From: David Whiteley
To: Stakeholder Steering Committee (SSC) Members and Stakeholders
Date: May 26, 2014

Re: Answers to Remaining Questions from May 7, 2014 SSC Webinar

Target 2 – Input Data and Assumptions
Exhibit 2 – AURORAxmp Topology

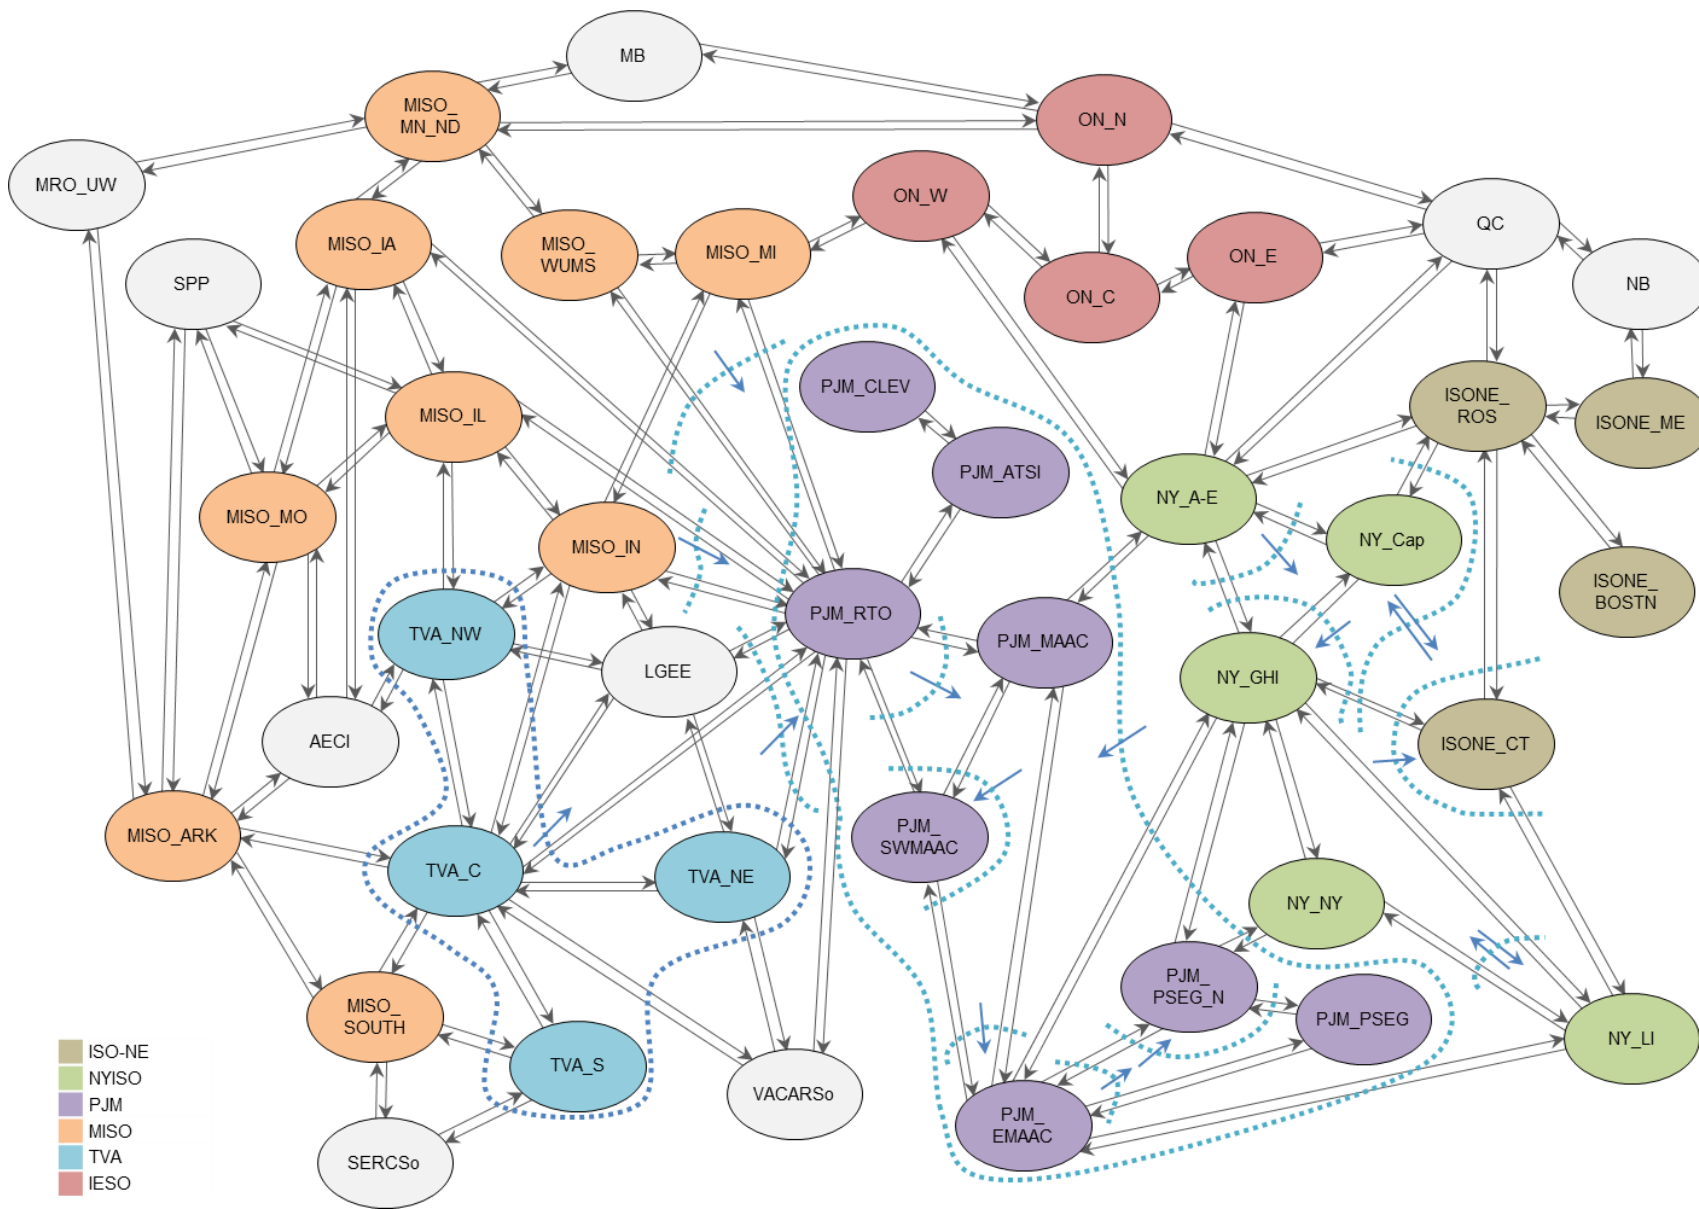
Question 1: The bubble diagram depicting the load zones and transmission interconnections between the zones that will be modeled in the Aurora production cost simulation was presented during the webinar. Slide 4 of the Target 2 Status presentation shows the Cleveland and ATSI bubbles connected to the PJM RTO bubble, but with no connection between them. If the Cleveland zone is truly “nested” within the ATSI zone, shouldn’t there be an interconnection between the two?

The bubble diagram shown on slide 4 of the Target 2 Status presentation was found to be in error. The Cleveland zone should in fact be connected to the ATSI zone which is then connected to the PJM RTO zone. The configuration used in the model set-up was determined to be correct, but the presentation diagram was incorrectly drawn. The revised/corrected diagram is shown in Attachment 1.

During the review of the bubble diagram, an additional revision was found to more accurately depict the connections of the AECl zone. That zone should have connections with TVA_NW (included on the May 7 version of the diagram), MISO_IOWA, MISO_MO, and MISO_ARK (previously labeled ENTG_ARK). The diagram was also missing a linkage between the QC and NB zones outside of the Study Region that will be modeled. These updates have also been made to the diagram in Attachment 1 and to the Aurora production cost model.

Finally, the revised diagram in Attachment 1 shows the multi-link interface limits as well transfer limits for each of the links between the zones that will be used in the Aurora modeling.

2. Revisions to the bubble diagram presented at the May 7, 2014 SSC webinar include:
 - Multi-link interface upper limits are also shown in this version (blue dotted lines and arrows).

- The PJM_RTO – PJM_CLEV link has been replaced with a PJM_ATSI – PJM_CLEV link.
 - A QC – NB link has been added to the model.
 - AECI – MISO_IA, AECI – MISO_MO, and AECI – MISO_ARK links have been added to the model.

- The previous ENTG_ARK zone has been renamed MISO_ARK for consistency with other MISO zone names.
